The ICTA notes the following:

Re: FTR and Transit Rate Proceeding – CD2012-1

LIME Response to second set of ICTA Interrogatories

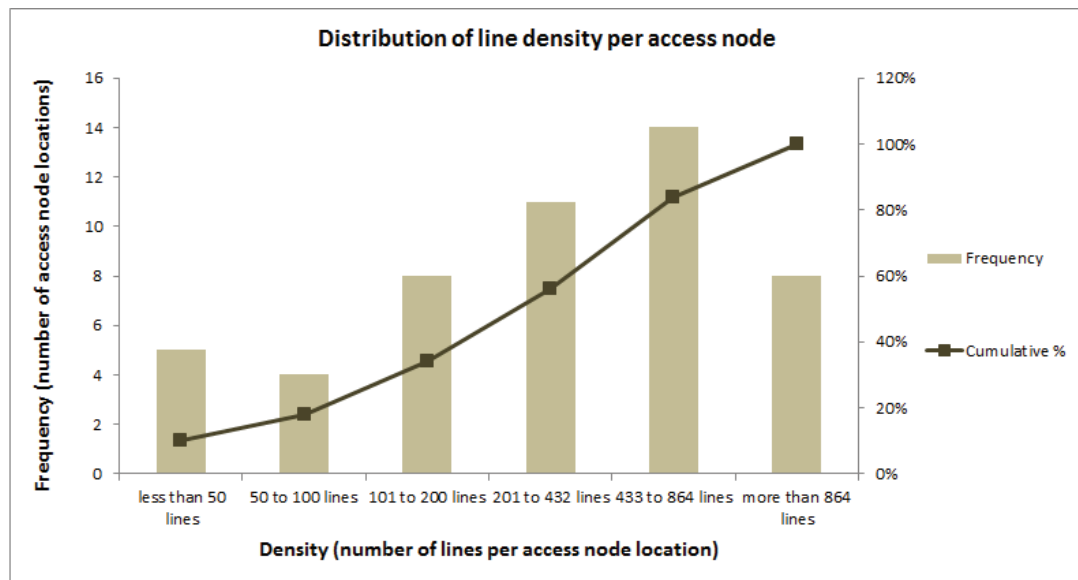
It appears that the costs of 'Spares' and 'Import duty' should be excluded from the formulas in cells F253:F257 as the descriptions given by LIME in cells C260 and D260 suggest that 'Spares' and 'Import duty' are not included in cells C261:D274.

LIME is requested to amend the formulas to reflect more correct estimation of 'Installation labour' costs, as for the example in cell F253 '=C253*(SUM(D\$261:D\$274)/SUM(C\$261:D\$274))', or to provide a detailed rationale for the existing calculation.

LIME response (31 July 2014): LIME has corrected the formula in cells F253:F257 as indicated. These changes are noted in the Change Log.
